# TOWN OF GLASTONBURY

**BID #GL-2011-08**

**PARKS & RECREATION OFFICES RENOVATIONS  
2143 MAIN STREET  
GLASTONBURY, CT 06033**

**ADDENDUM #3  
Dated: 04/20/2011**

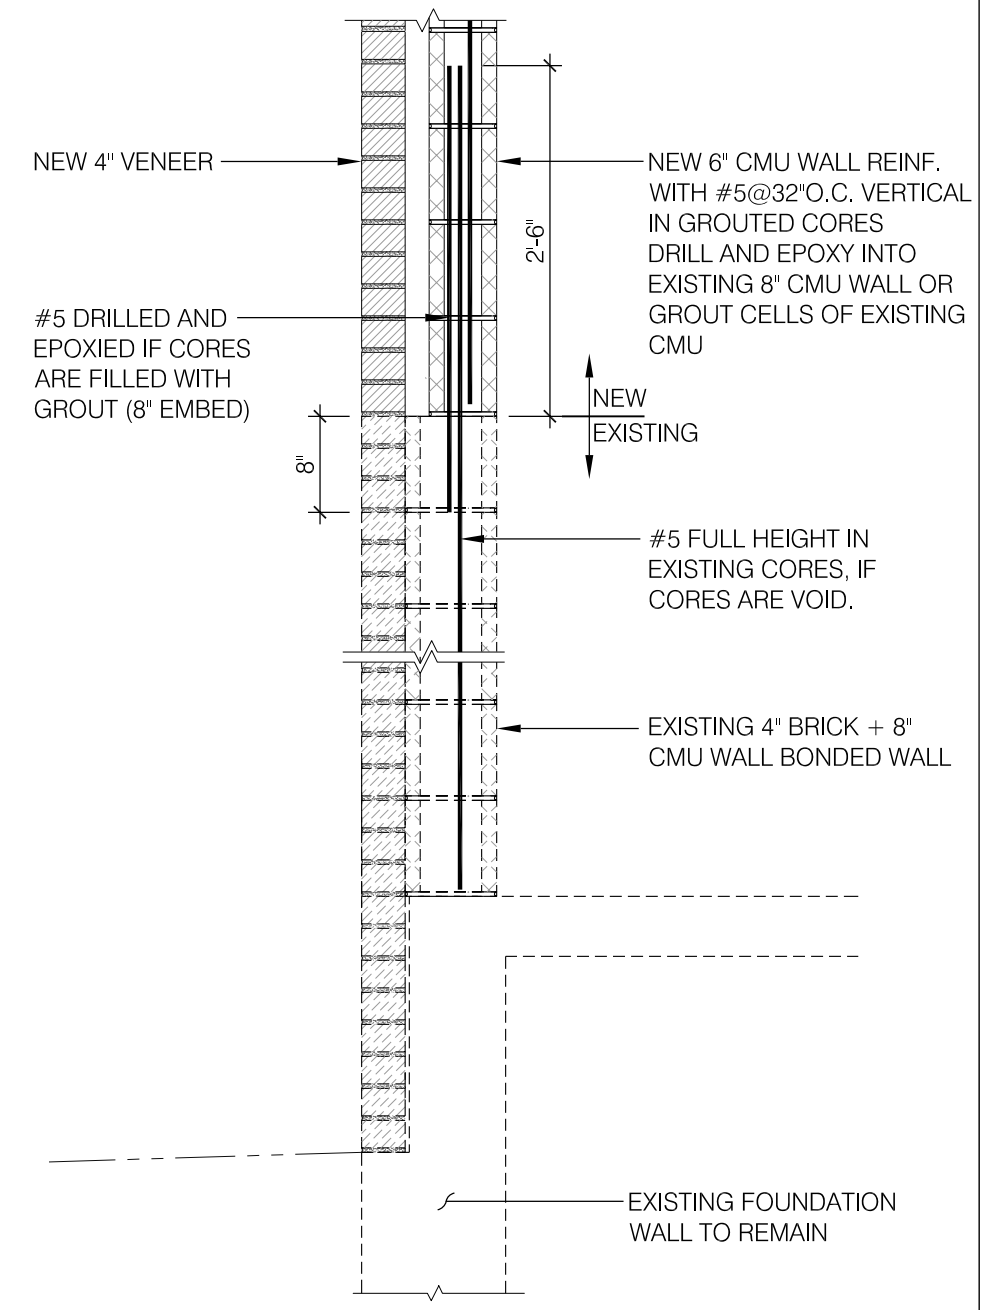
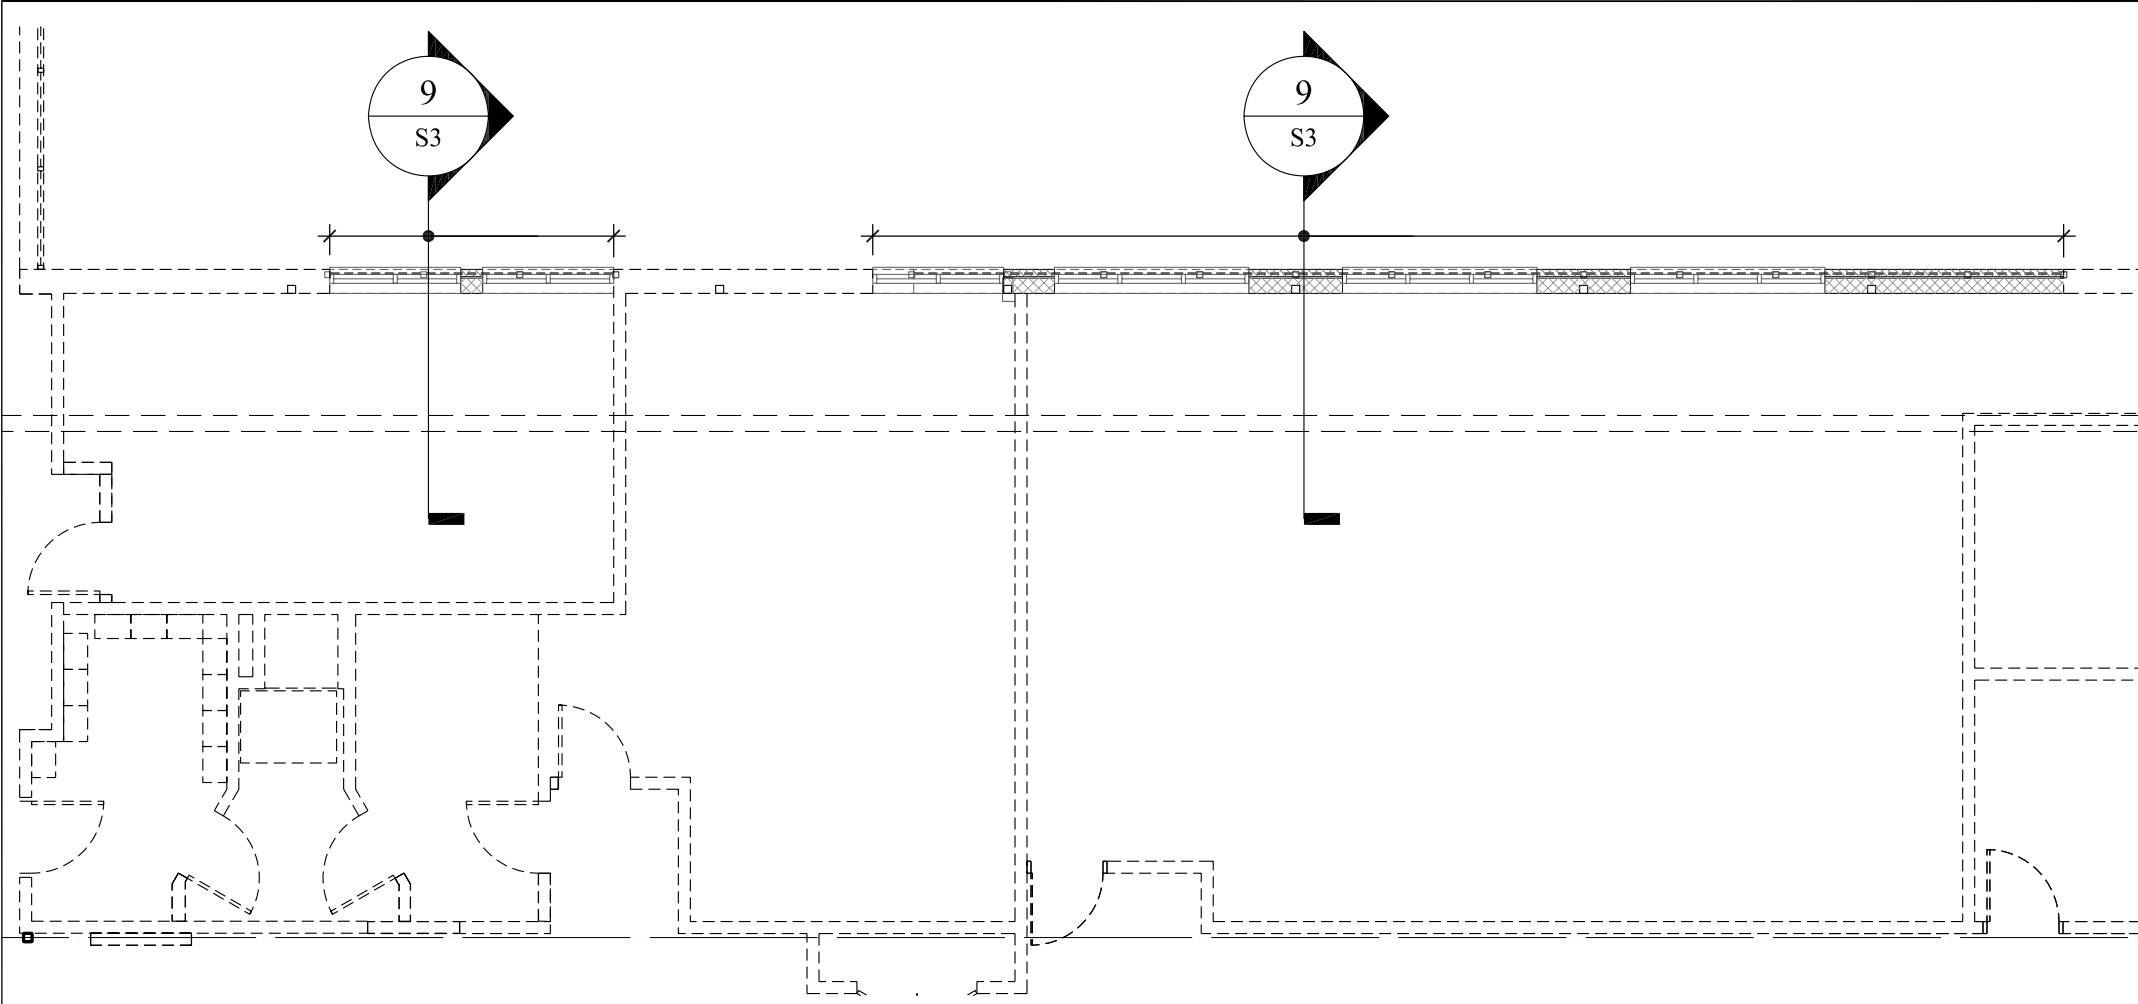
7. **Question:** Regarding Alternate 3; Detail 2/A8 does not show new brick below new window sill elevation. Detail 1/S3 shows new interior CMU from top of wall. Please clarify.

**Answer: Drawing SKS-01 has been attached.**
8. **Question:** Can you provide an approximate depth below finish floor that the sanitary tie-in for the new bathroom is as shown on P1? Perhaps there are as-builts that show this elevation.

DRAWING SKS-01, NEW SECTION 9/S3 has been added and is attached as part of this addendum. This information revises and adds information to Drawing S3.
